Field Safety Notice (FSN) SwiftHook - Product Removal

HANDICARE AB

MANUFACTURER FSCA/FSN REFERENCE: C083

FSN TYPE: UPDATE OF FIELD SAFETY NOTICE 2020-DEC-20

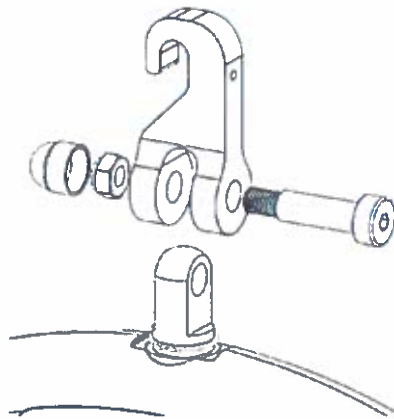
It has come to our attention that the spreader bar may detach during use of mobile lifts and ceiling lifts equipped with the SwiftHook attachment.

Attaching a weight load to the mobile lift or ceiling lift with SwiftHook in an unstable position could cause the SwiftHook and attached parts, including patient seated in the sling, to detach from the lift arm.

Corrective Action - Direct Mounting of Spreader Bar onto Mobile Lift or Ceiling Lift

Please observe that users can mount the spreader bar directly onto the lift arm of the mobile/ceiling lift. This corrective action must be undertaken.

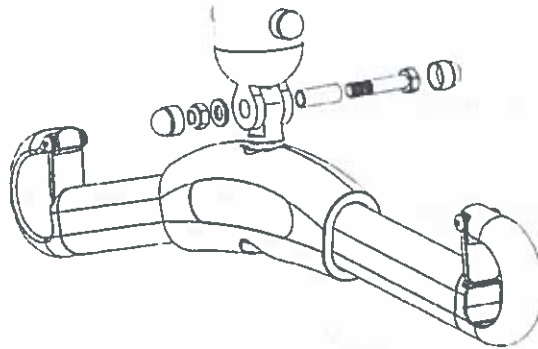
1. Remove the SwiftHook using the appropriate Allen key (5mm) and wrench (13mm). See figure below.

2. Use two wrenches (13mm). Remove the SwiftHook from the spreader bar as above. Remove the fastener from the lift's link arm as described in the figure below. Attach the spreader bar directly to the lift arm, as illustrated in the second figure below, by using the existing fasteners from the link arm.
